Adopt the attached resolution opposing the establishment of a Los Angeles Unified School District Public High School at 4110 South Santa Fe Avenue, Long Beach, and oppose the certification of the associated EIR (SCH# 2005041116) by the Los Angeles Unified School District School Board, on April 24, 2007. (District 8)

SOUTH REGION HIGH SCHOOL # 4
Los Angeles Unified School District

**RE: Comments on Draft Environmental Impact Report
Proposed South Region High School No. 4
State Clearinghouse No. 2005041116**

SITE OPTION # 1A

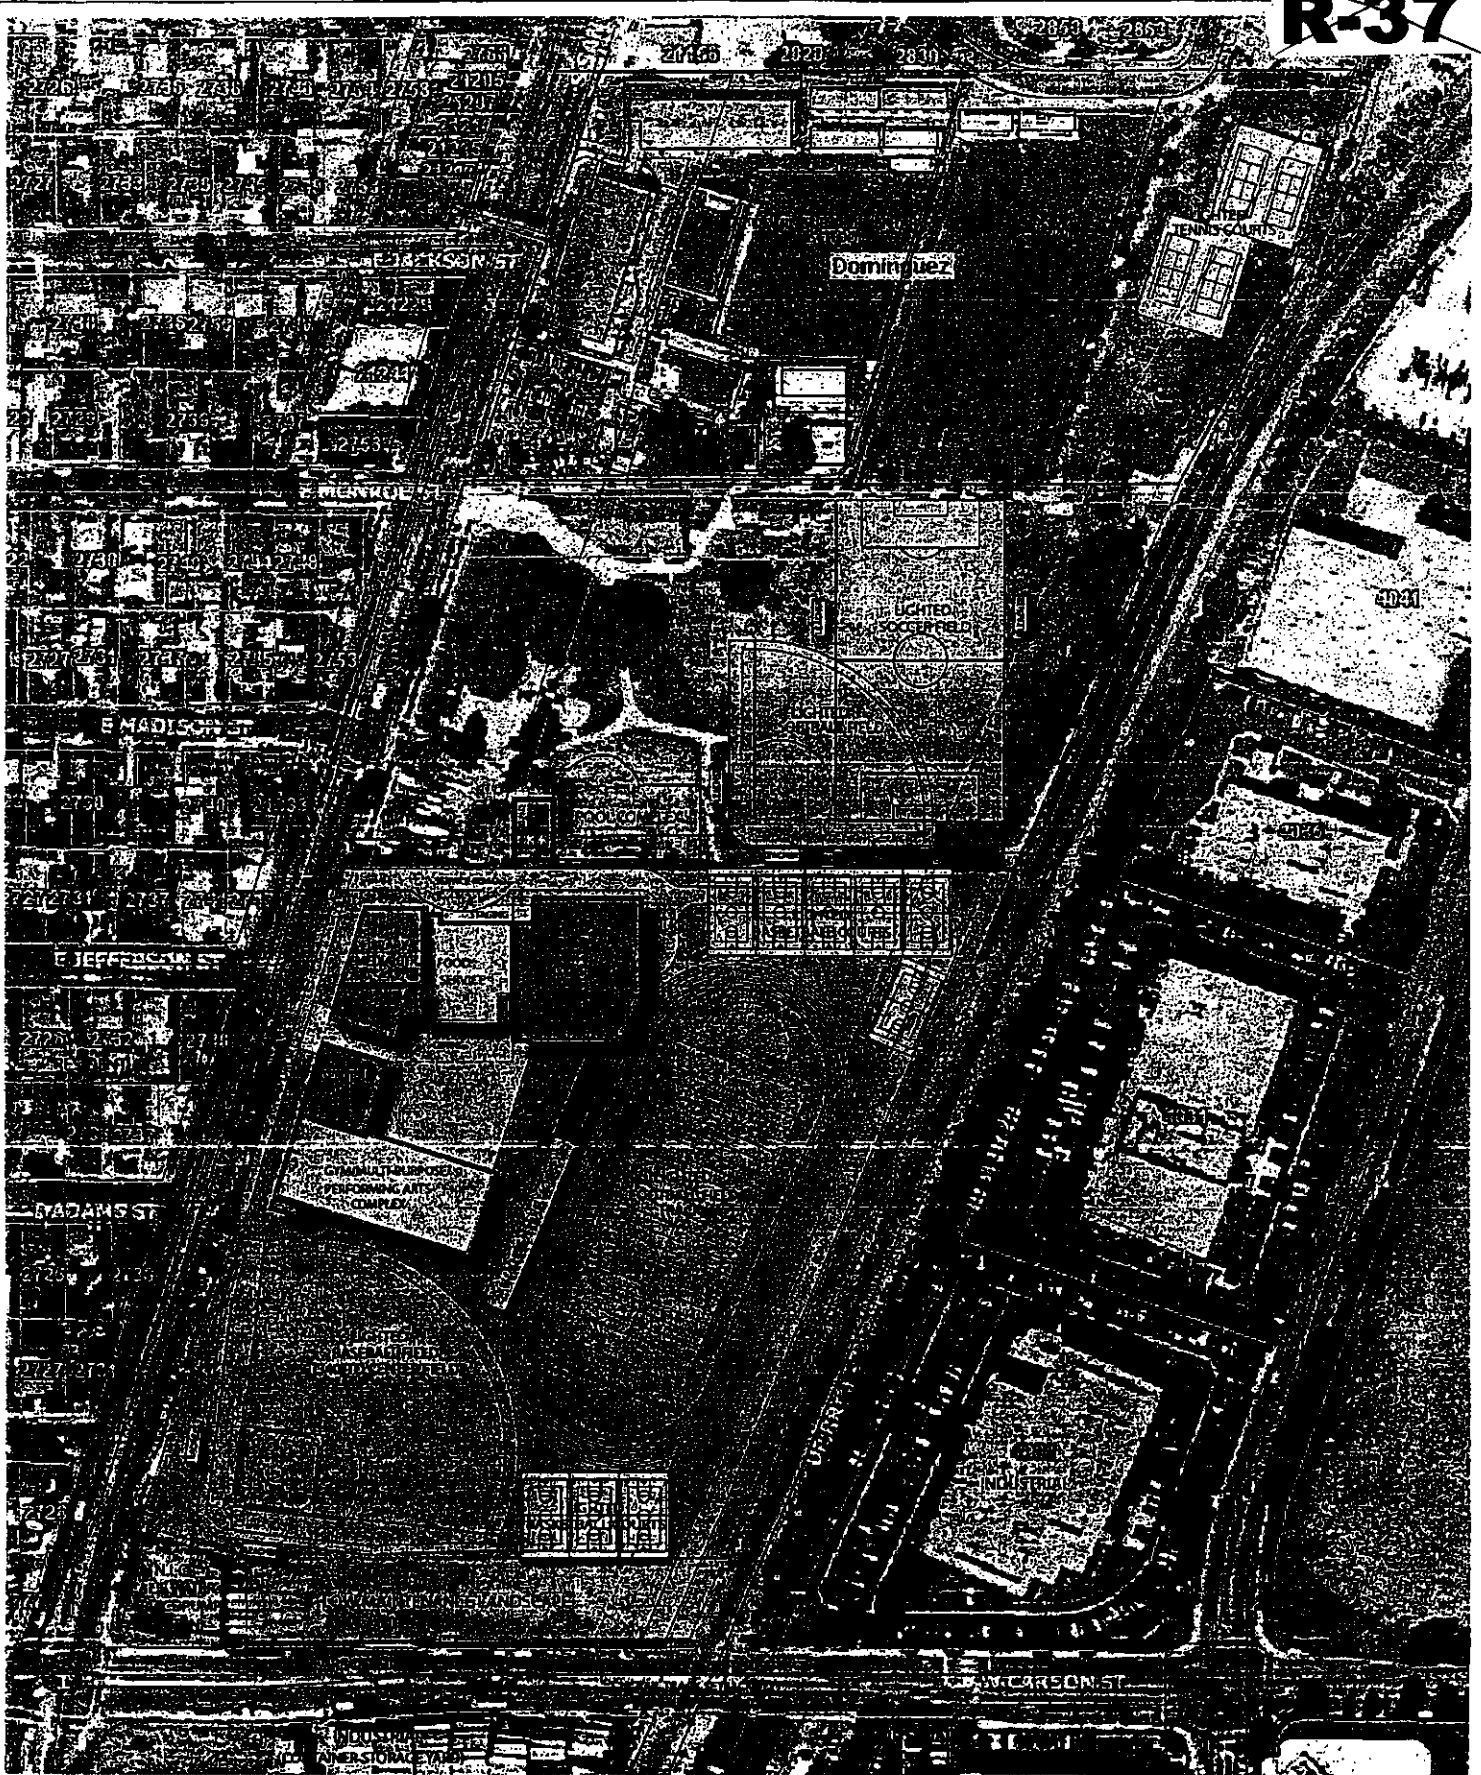
The EIR indicates that an on-site bus drop off zone will be provided; however, it is unclear from the Site Plan where such a zone would be located or how a bus would enter, maneuver within the project site, and leave the project site. Since a number of the internal drivable pathways traverse athletic facilities, primary walkways, and assembly areas, bus travel within the project site could be restricted as well as pose significant student safety issues.

- The recirculated EIR must accurately show the proposed on-site school bus drop-off location and provide a thorough analysis of this drop-off area on the surrounding street system.
